**RESPONSE TO COMMENTS RECEIVED CONCERNING
THE DALLAS-FORT WORTH (DFW) ATTAINMENT
DEMONSTRATION (AD) STATE IMPLEMENTATION
PLAN (SIP) REVISION FOR THE 1997 EIGHT-HOUR
OZONE STANDARD**

PROPOSED JUNE 8, 2011

Figure 1: Weather adjusted Ozone Trend for DFW as Published by the EPA

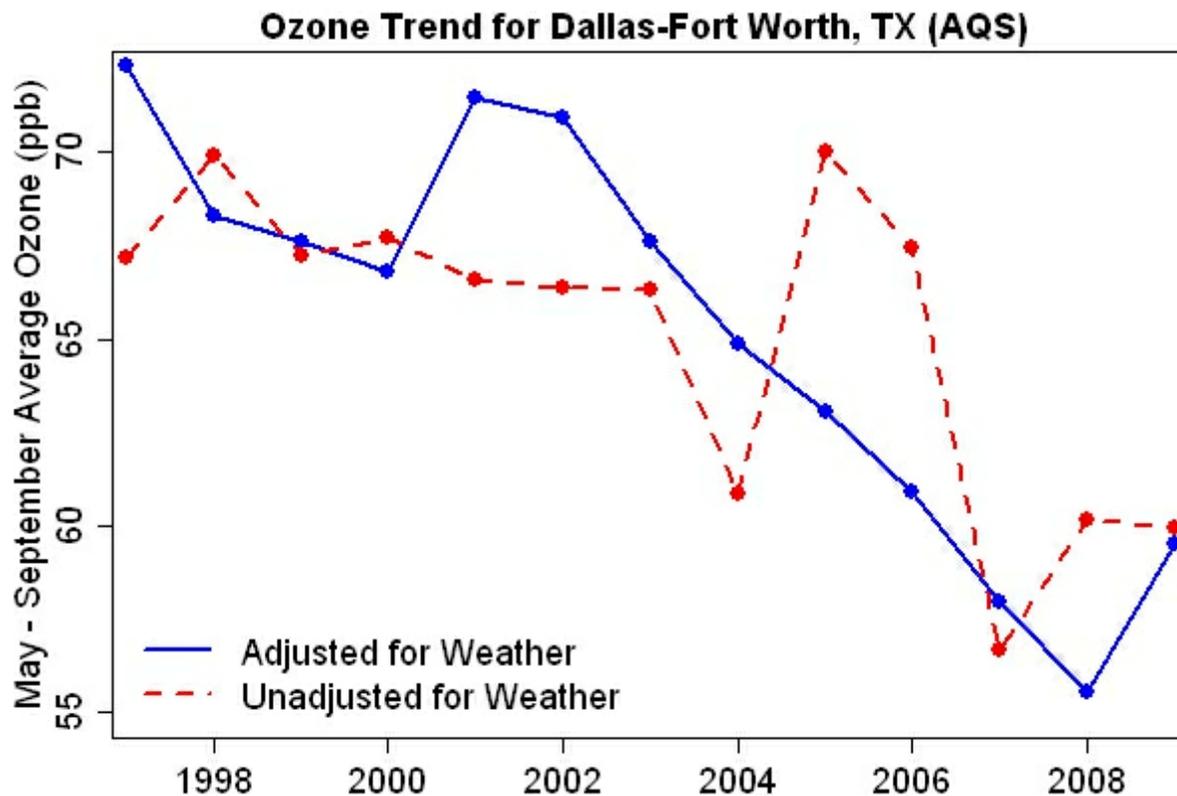
In general, periods of high wind speeds tend to dilute pollutants. However only small periods of slow wind speeds, like wind reversals, can cause an accumulation of pollutants, thereby creating higher ozone concentrations. Moreover, there are many other meteorological variables other than wind speed that contribute to ozone formation.

The EPA publishes weather-adjusted ozone trends for many areas of the country, including the DFW area, that take into account many additional meteorological factors than just wind speed (<http://www.epa.gov/airtrends/weather.html>). *Figure 1: Weather adjusted Ozone Trend for DFW as Published by the EPA* shows that when meteorological factors are removed the adjusted annual ozone concentrations are lower than the observed, indicating that the ozone reductions are due to more than meteorology (e.g. emission reductions). Again, wind speed alone is not sufficient to characterize ozone-conducive conditions.

Figure 3: Kv-100 Sensitivity

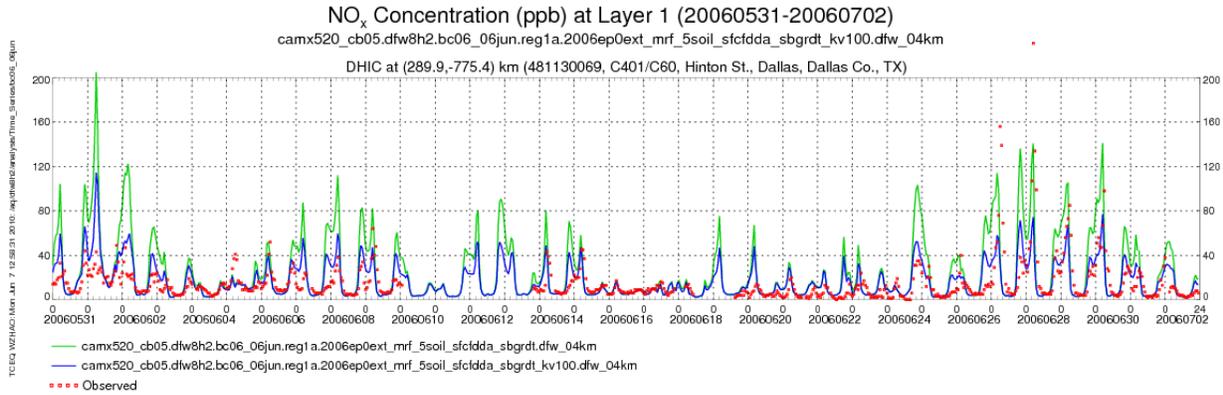
The EPA stated that they believe the model is responding too strongly to changes in NO_x emissions, and they state that the model performance and diagnostic tests support this position.

Figure 3: *Kv-100 Sensitivity* shows a time series during the episode of NO_x concentrations, comparing Dallas Hinton C401 NO_x observations with a model run not using a patch (green line) and one using a Kv-100 patch (blue line). Without a patch, the overnight NO_x concentrations are almost always overestimated. With a Kv-100 patch (minimum vertical diffusivities set through 100 meters above ground), the overnight concentrations represent the observations much better.
